CBER CMC BLA Review Memorandum

BLA STN 125685

Allogeneic processed thymus tissue-agdc

Enzyvant Therapeutics GmbH

Figure 1. Graph of (b) (4) facility deviations by category (supplied by Applicant)

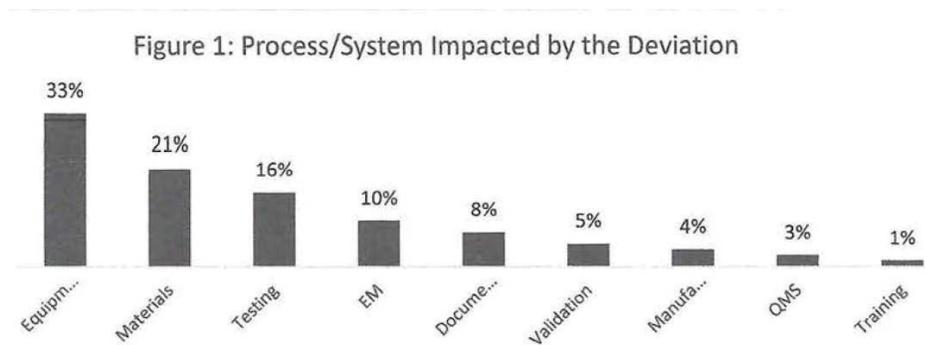
All deviations reviewed were closed, but 41% still had open CAPAs. Their review revealed that root cause analysis needed improvement. Based on the risk assessment score provided at the time they evaluated whether a CAPA was deemed necessary, and if so were corrective actions taken. They found 100% of the time when a CAPA was required it was initiated, and 38% of the time when it was optional.

Note: A review of risk assessment for some of these and other deviations examined on inspection suggested that no corrective actions were taken because risk assessment scores were assigned a low value. It was questionable if these scores were accurate in some cases (please refer to the Establishment Inspection Report). If they are only looking to see if corrective actions were taken as dictated by the original score, then the review would be fully informative. For example, in response to CRL item #1, observation #1, they indicated that if these cited deviations would occur now with the new quality risk management system in place, that corrective actions that were not previously taken would be taken now.
